**NORTH KERN WATER STORAGE DISTRICT**

Attached is Addendum No. 5 to the  
Specifications No. NK-619 for  
PIPELINE AND PUMP STATION PROJECT

### ADDENDUM NO. 5 TO THE SPECIFICATIONS NO. NK-619 for PIPELINE AND PUMP STATION PROJECT

ENLARGED PLAN NO. 14 - WELL 88-25-016  
SCALE: 1"=5'

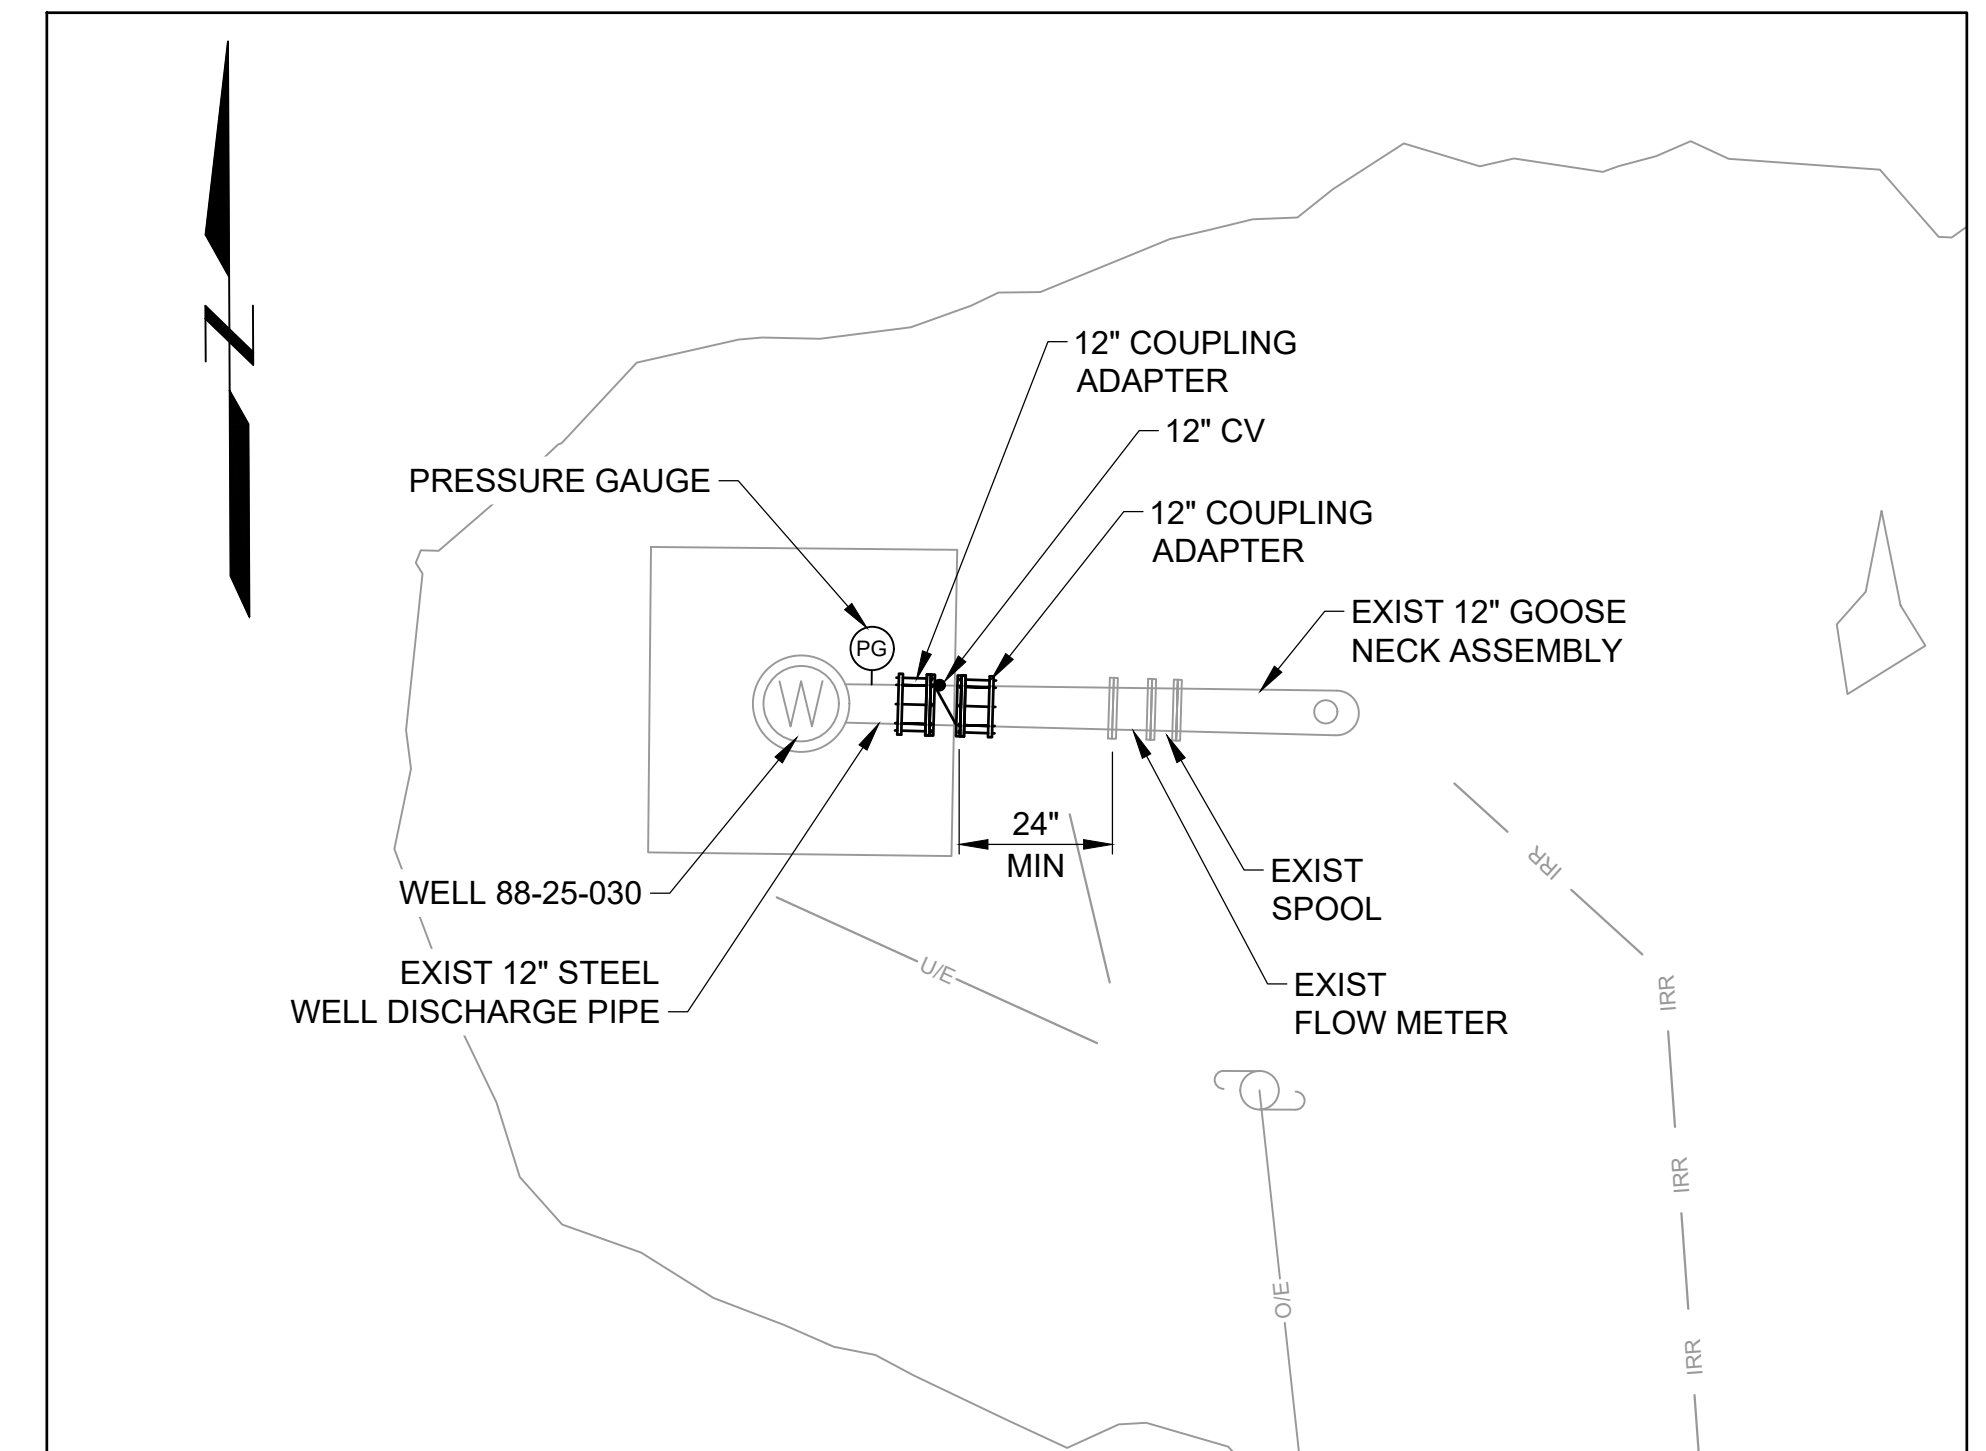
Revised well connection gooseneck assemblies and mag meters to “EXIST” for the following details:

- i. ENLARGED PLAN NO. 13 – WELL 88-29-006
  - ii. ENLARGED PLAN NO. 14 – WELL 88-25-016
  - iii. ENLARGED PLAN NO. 17 – WELL 99-00-032
- g. Drawing No. C-104. Sheet No. 46. Added General Note No. 5 “THE MINIMUM LENGTH OF UNOBSTRUCTED STRAIGHT PIPE FOR THE 18” MAG METER SHALL BE 36” UPSTREAM AND 18” DOWNSTREAM OF THE METER”.

ENLARGED PLAN NO 18 - 88-25 WELLS PIPELINE  
SCALE: 1"=20'

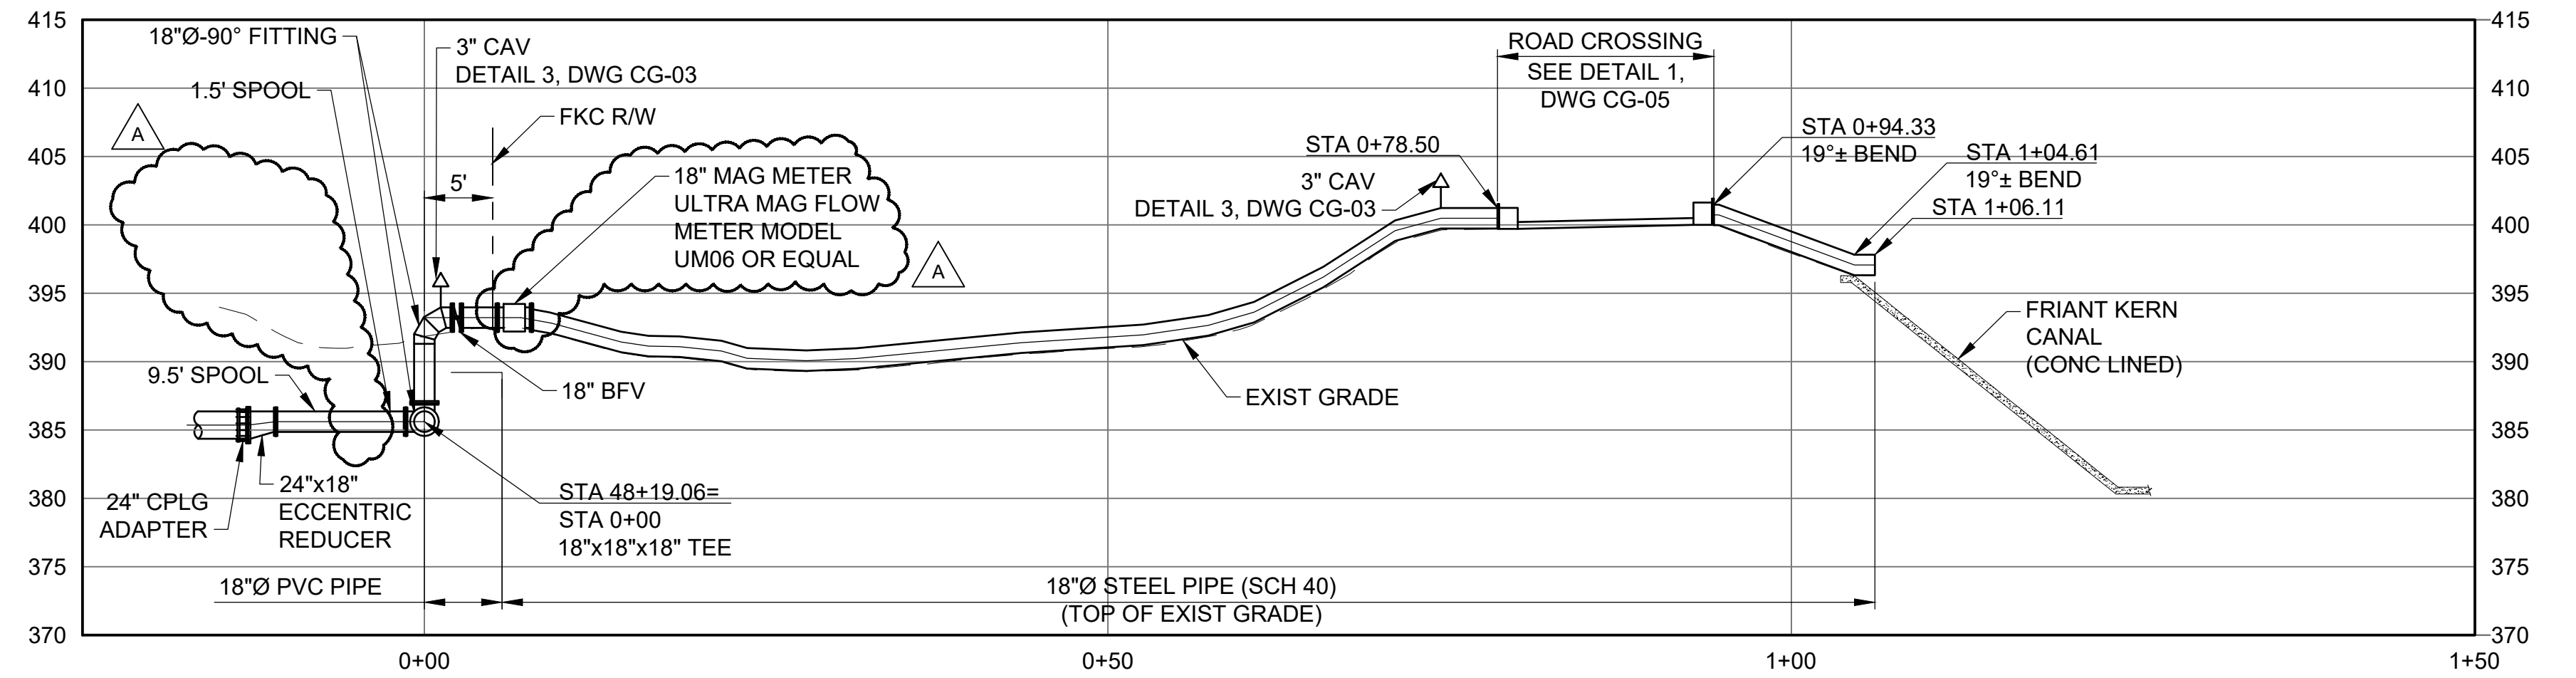
- i. ENLARGED PLAN NO 18 – 88-25 WELLS PIPELINE and SECTION A. Deleted belowground 18” mag meter and vault (1 each). Added aboveground 18” mag meter (2 each) on steel pipe.

ENLARGED PLAN NO 19- ROSEDALE PUMP STATION DISCHARGE PIPELINE  
SCALE: 1"=20'

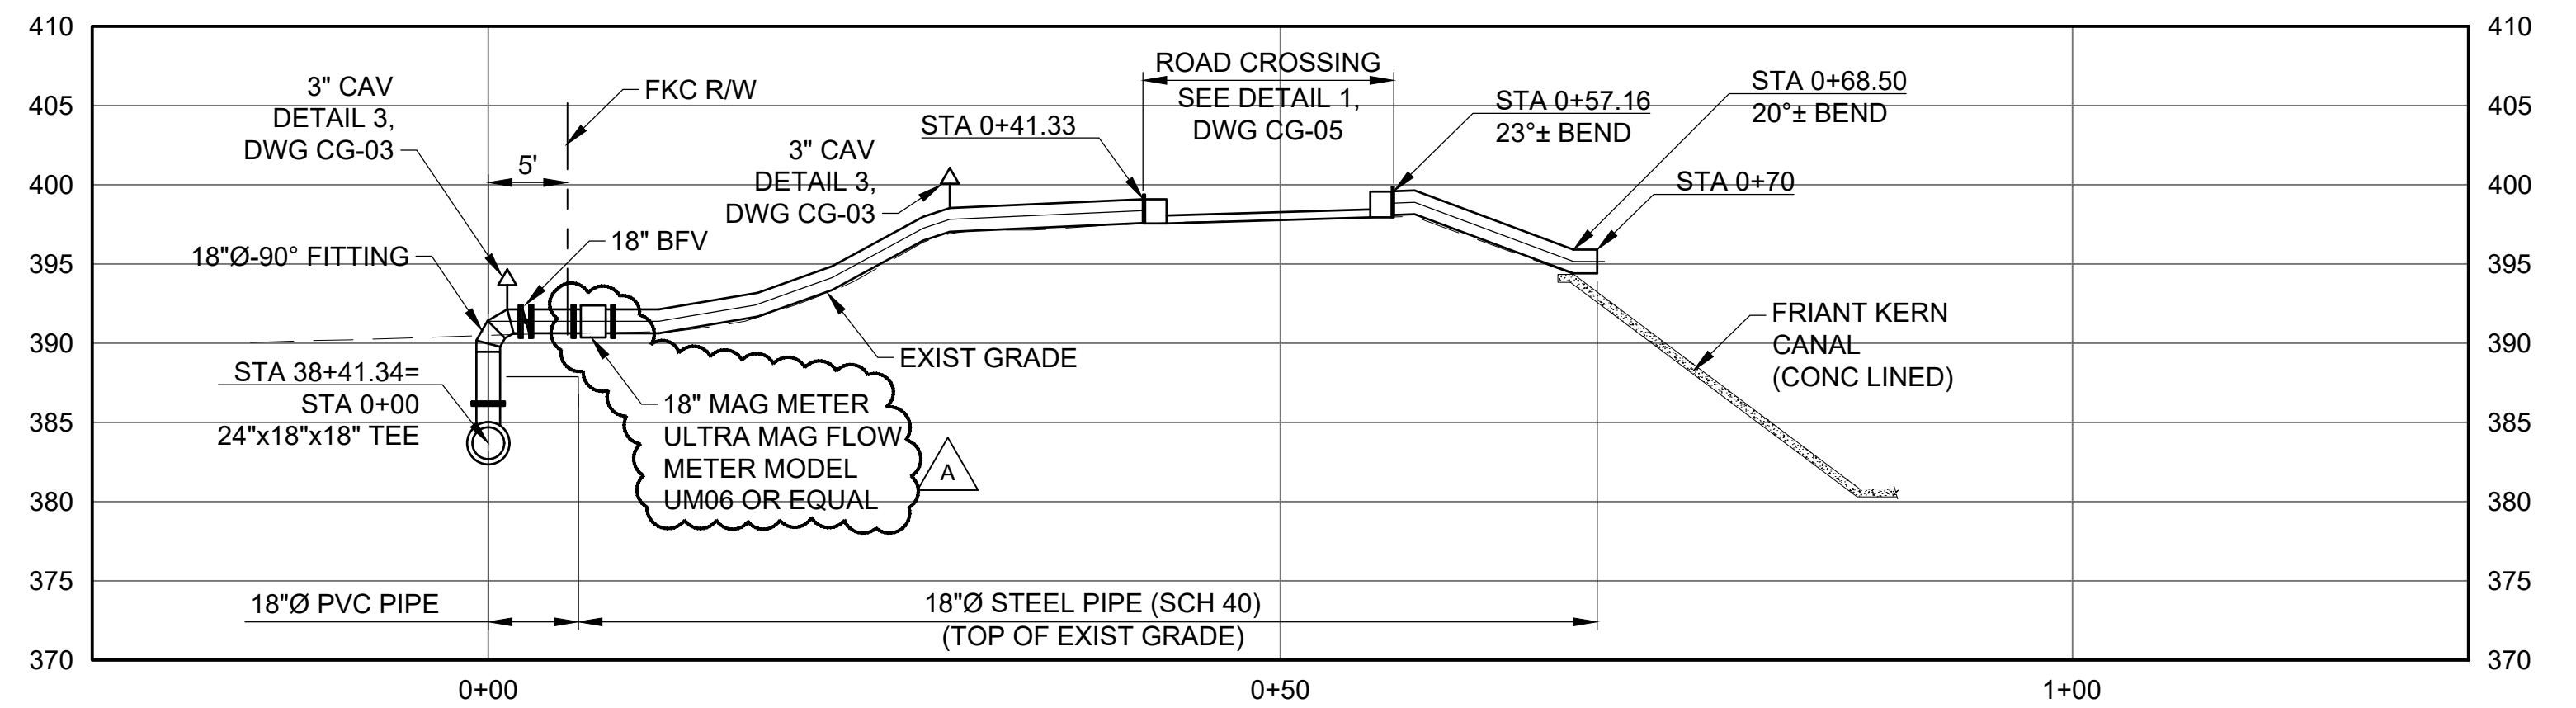
- ii. ENLARGED PLAN NO 19 – ROSEDALE PUMP STATION DISCHARGE PIPELINE and SECTION B. Added aboveground 18” mag meter (5 each) on steel pipe.
- h. Drawing No. CG-02. Sheet No. 49. Deleted Detail 4.

**1**  
-  
**18"x12' ROAD CROSSING**  
NO SCALE

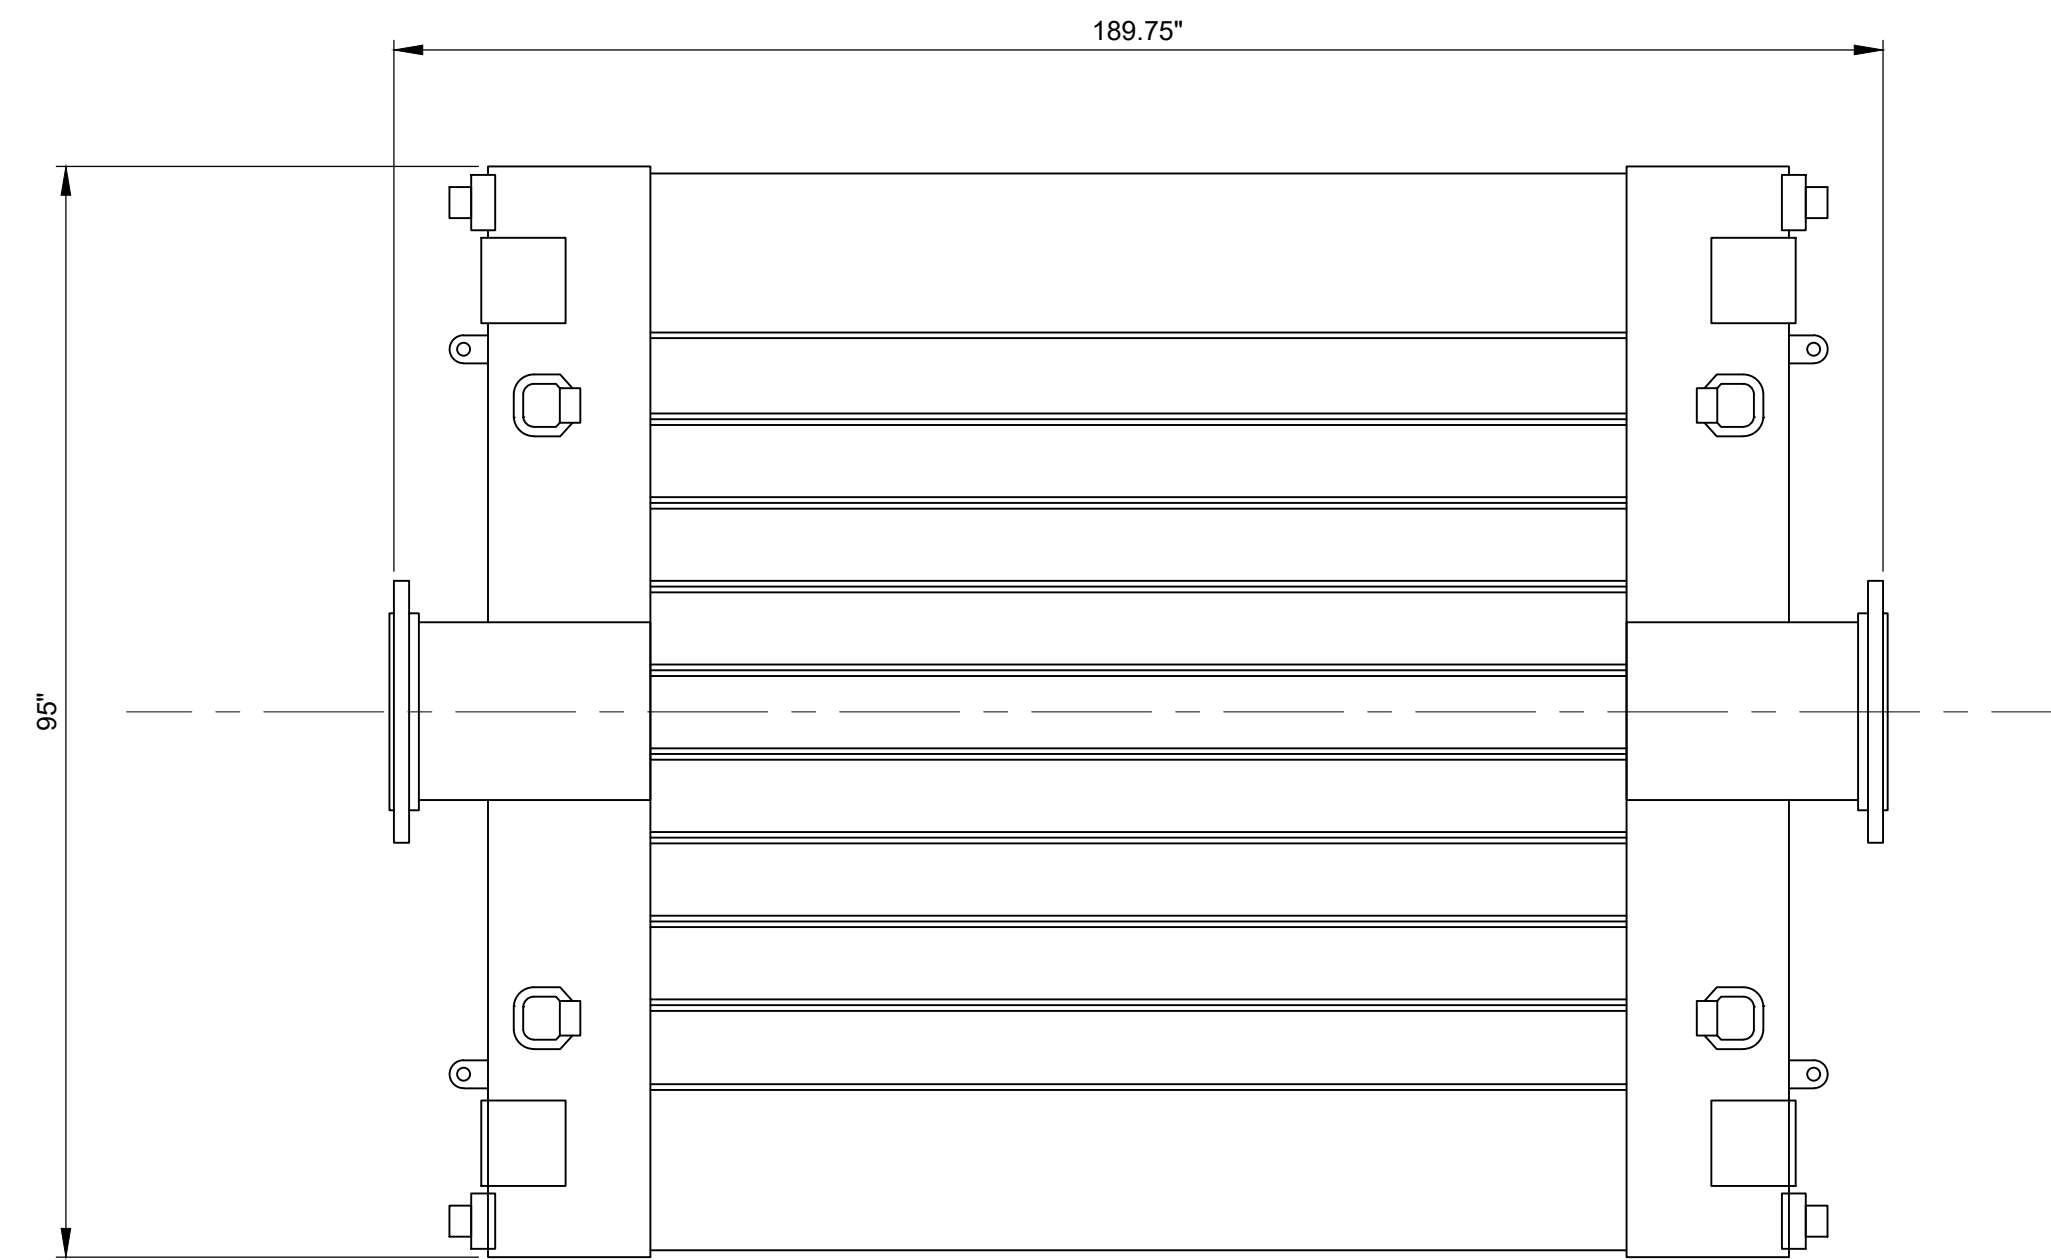
- i. Drawing No. CG-03. Sheet No. 50. Deleted Detail 5.
- j. Drawing No. CG-05. Sheet No. 52. Added Note No. 1 for Detail 1 “THE ROAD CROSSING SHALL BE 18”x12” ROAD CROSSING BY RAIN FOR RENT OR EQUAL”

**Q14:** We do not find any other specification or description for these road crossings other than what is shown on the referenced detail. Further, there is some type of description above Detail one in a bold blue table, but this is not legible. Please provide a better description and a legible detail for these road crossings.
